Access Compliance Report

Public Rights-of-Way

(Curb Ramps)

Intersection ID: 28499	Main Street: BIRD_WATCH_LN	Cross Street: NORTHWOODS_FOREST_DR	Location: S
ADA ID: A010E6DE9ACB	Ramp Type: BlendTrans2	Initial Pass/Fail: Fail	Overall Compliance: No
Severity Score: 17.5			
Codes/Mitigation Info/Possible Solution		Field Measurements/Component Compliance

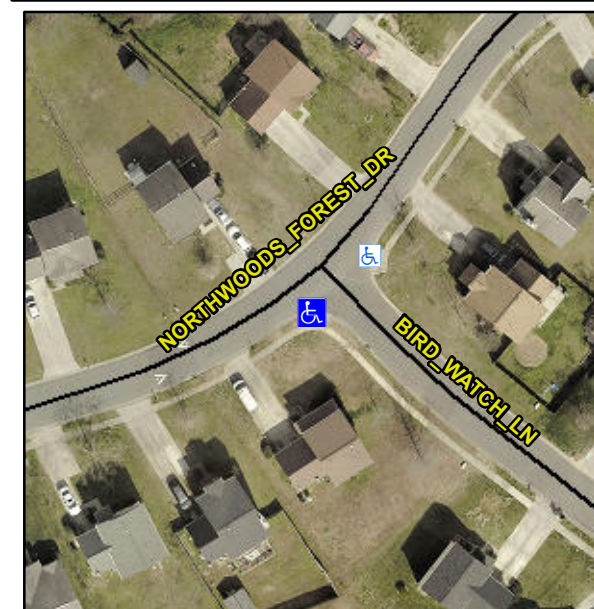
Compliance	Description	Data	Compliance	Description	Data
N/A	Ramp Length (in)	96.0	Yes	BlendTrans Slope (%)	4.2
No	Ramp Width (in)	35.5	Yes	BlendTrans XSlope (%)	0.2
N/A	Flare Type LT	N/A	N/A	Flare Type RT	N/A
N/A	Flare Slope LT (%)	N/A	N/A	Flare Slope RT (%)	N/A
N/A	Flare Traversable LT?	N/A	N/A	Flare Traversable RT?	N/A
N/A	Landing Length (in)	N/A	N/A	DWS Provided?	N/A
N/A	Landing Width (in)	N/A	N/A	DWS Contrast?	N/A
N/A	Landing Slope (%)	N/A	N/A	DWS Length (in)	N/A
N/A	Landing X Slope (%)	N/A	N/A	DWS Full Width?	N/A
N/A	Landing Curb? (Y/N)	N/A	N/A	DWS Offset (in)	N/A
N/A	Shared Landing?	N/A			
N/A	Gutter Ponding?	N/A	N/A	Gutter Slope (%)	N/A
N/A	Gutter Lip Ht (in)	N/A	N/A	Gutter X Slope (%)	N/A
N/A	Painted X Walk1?	No	N/A	Painted X Walk2?	N/A
	X Walk 1 Direction	To NE		X Walk 2 Direction	N/A
	X Walk 1 Width (in)	N/A		X Walk 2 Width (in)	N/A
	X Walk 1 Slope (%)	0.1		X Walk 2 Slope (%)	N/A
	X Walk 1 X Slope (%)	2.3		X Walk 2 X Slope (%)	N/A

N/A	Ramp inside XWalk1?	N/A	N/A	Ramp inside XWalk2?	N/A
	Road Slope (%)	2.3		Clear Space?	N/A
	Road X Slope (%)	0.1	N/A	Clear Space to XWalk (in)	N/A
N/A	Any Obstructions?	N/A	N/A	Storm Grate/Utility Hazard?	N/A
	Obstruction Type			Storm Grate/Utility Type	
		N/A			N/A
			Yes	Surface Condition? (G/P)	Good
			N/A	Curb Slope (%)	2.7

Remove & Replace Curb Ramp With Two New Directional Ramps or Equivalent.
